# ***Latch Handle Disable Alternate Method - Final***

**National Traffic and Motor Vehicle Safety Number (NHTSA):** NHTSA recall number: 09V-318, Transport Canada number 09-240

**Figure 1-1 Transom Window Latch (Closed Position)**

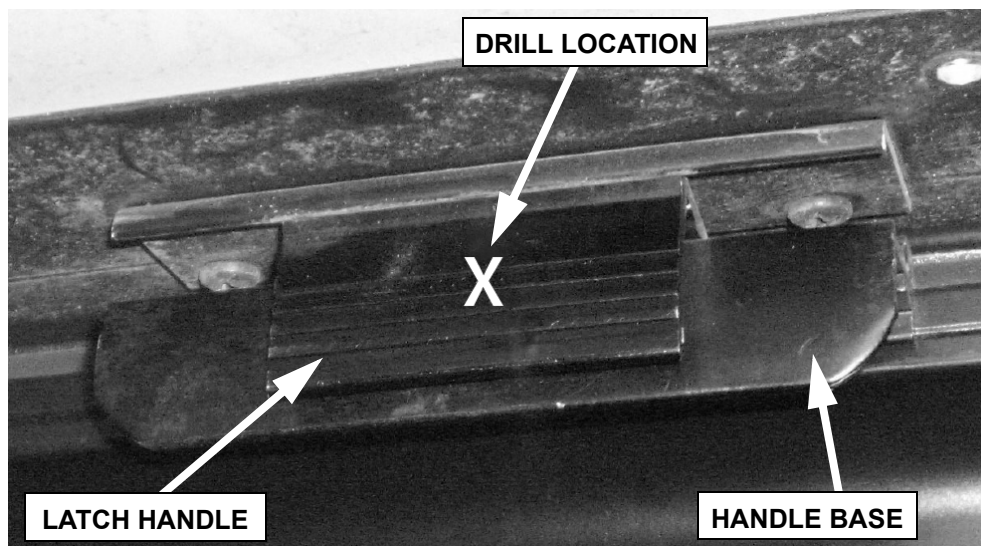
1. Ensure that the transom window is closed. See [Figure 1-1](#).
2. Drill a 9/64" hole through the center of the latch handle and handle base. See [Figure 1-1](#).

**Figure 1-2 Transom Window Latch Disabled**

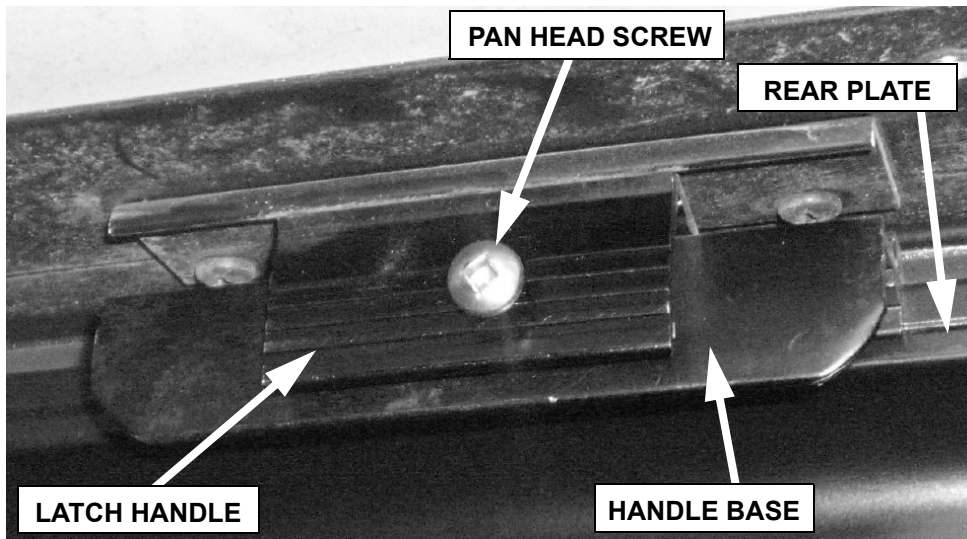
3. Drive a #10 X 1/2" pan head screw through the latch handle and into the handle base. See [Figure 1-2](#).

**Only drive the screw through the latch handle and base. Do not drive the screw through the rear plate. See [Figure 1-2](#)**
